Review of Department of Defense Test Protocols for Combat Helmets

Committee on Review of Test Protocols Used by the DoD to Test Combat Helmets;
Board on Army Science and Technology; Division on Engineering and Physical
Sciences; National Research Council

First Article Testing Protocols for Resistance to Penetration: Statistical Considerations and Evaluation of DoD Test Plans

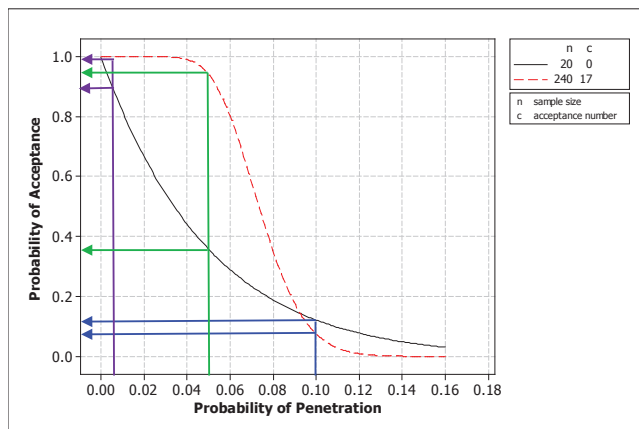
Figure 6-5 provides a comparison of the OC curves for the (0, 20) and (17, 240) plans. The two OC curves cross at about $\theta = 0.092$. The (0, 20) plan has higher acceptance probabilities to the right of this penetration probability and has lower acceptance probabilities to the left. The two plans have about the same acceptance probabilities (government risks), in the neighborhood of $\theta = 0.10$, as intended.

When $\theta = 0.005$, near the region where the manufacturers are currently operating (see Chapter 5), the acceptance probability of the (0, 20) plan is about 0.9, while that of the (17, 240) plan is essentially 1.0. Thus, the (17, 240) plan has

Consider a comparison of the two plans when the penetration probability equals 0.05, which is a 10-fold increase in the penetration probability from the currently achieved level of around 0.005. For this value of $\theta = 0.05$, the acceptance probability is about 0.38 for the (0, 20) plan, while it is about 0.95 for the (17, 240) plan. Thus, even if there is a 10-fold degradation in the penetration resistance of helmets, there is a 95 percent chance of accepting the helmets under the DOT&E protocol. Similar comparisons can be made at other values of θ to the left of the point where the two curves cross. For example, for any values of penetration probability of $\theta \leq 0.04$ —a five-fold increase—the helmets will almost certainly be accepted. To the right of the crossing point, however, the (0, 20) plan has a higher acceptance probability (and hence poorer performance in terms of screening out helmets with high penetration probabilities, but still less than a 12 percent chance of acceptance).

there is a 10-fold increase in the current penetration probability (from 0.005 to 0.05), this may provide a disincentive to maintain current levels of penetration resistance. In this sense, the (17, 240) plan is not as good as the legacy plan of (0, 20).

Recommendation 6-2. If there is a scientific basis to link brain injury with performance metrics (such as penetration frequency and backface deformation), the Director of Operational Test and Evaluation (DOT&E) should use this information to set the appropriate standard for performance metrics in the test protocols. In the absence of such a scientific basis, DOT&E should develop a plan that provides assurance that it leads to the production of helmets that are at least as penetration-resistant as currently fielded helmets.

FIGURE 6-6 Comparison of the operating characteristic curves for (0, 20) and (5, 96) plans.

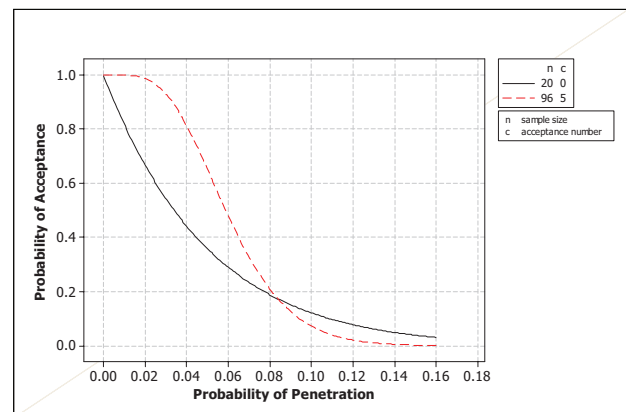
The ECH protocol, a modification of the DOT&E protocol, is a 5-out-of-96 (5, 96) plan that involves taking two shots each at 48 helmets. The acceptance limit of $c = 5$ is based on the 90/90 criterion. Figure 6-6 provides a comparison of its OC curve with that of the (0, 20) plan. It shows that, if the penetration probability is 0.035, the manufacturer's risk

is about 0.10 (i.e., there is a 90 percent probability of acceptance). Again, this is about an order of magnitude greater than the penetration probability that available data indicate. The above findings and recommendations pertaining to the full DOT&E protocol also apply here.

FIGURE 6-7 Operating characteristic curves for the hybrid plan and comparison to others.

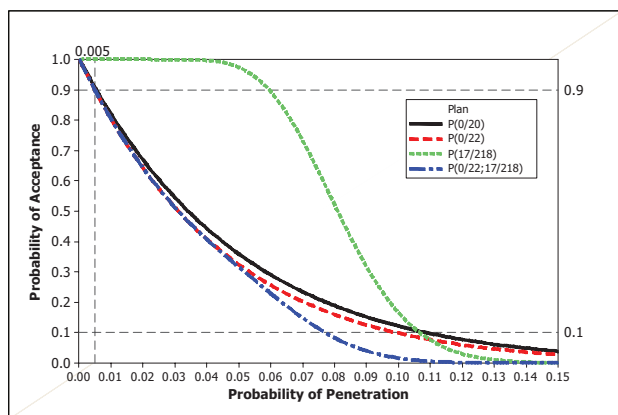
Figure 6-7 provides a comparison of the OC curves of the hybrid plan with its component plans and also the legacy

plan of (0, 20). It is intuitively clear that the OC curve of the hybrid plan should be below that of its two component plans—(0, 22) and (17, 218)—because it is more stringent than either one. Figure 6-8 confirms that this is indeed the case. The plan's government risk when $\theta = 0.005$ is around 0.10 (i.e., there is a 90 percent chance that helmets with penetration probability of 0.005 will be accepted). This is comparable to the (0, 20) legacy plan and also the first-stage (0, 22) plan. The government's risk when $\theta = 0.10$ is close to zero and much lower than the other three plans being compared.

With this hybrid protocol, the Army has actually made this hybrid test plan more stringent than the earlier (0, 20) plan, particularly for penetration probabilities in the range of 0.05 to 0.12.
